SCH3227/SCH3226/SCH3224/SCH3222

Silicon Errata and Data Sheet Clarifications

1. Module: Serial Port

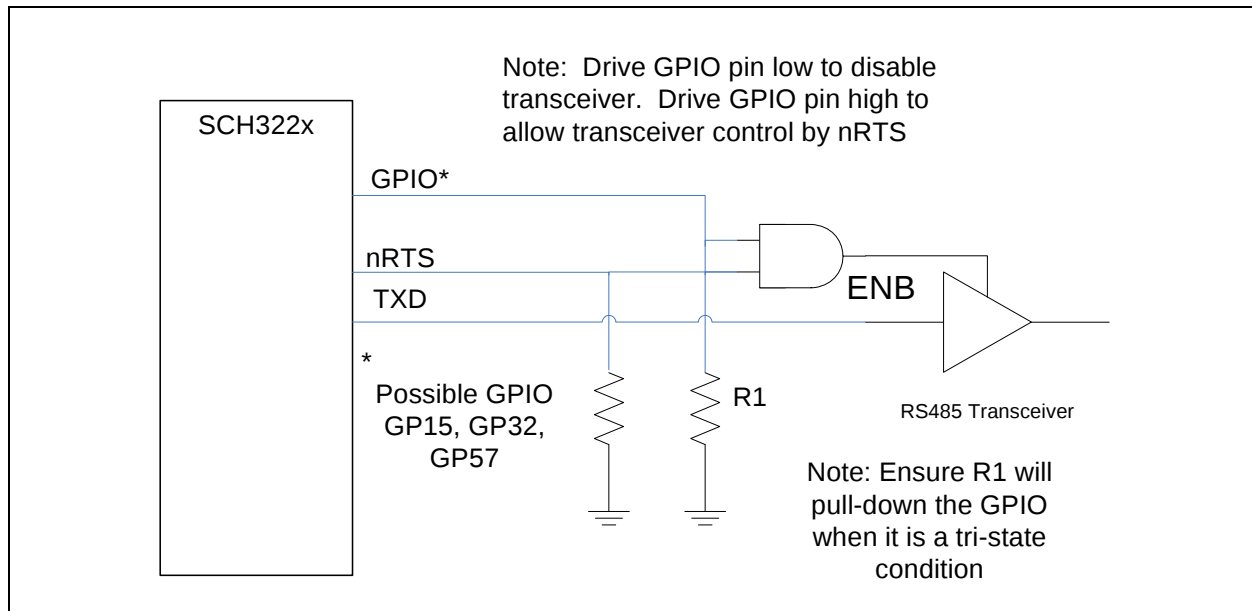
UART 3 and UART 4 do not tri-state their outputs on a PCI_RESET as do UART 1 and UART 2.

UART 3 and UART 4 outputs are not controlled by the Configuration Register 0x30 ACTIVATE bit.

UART 3 and UART 4 outputs will drive High when PCI_RESET goes active or when the ACTIVATE bit is cleared, and if the platform uses RTS to control an RS485 transceiver this may interrupt communication.

Use GPIO pin to disable RS485 transceiver when ACTIVATE bit is cleared.
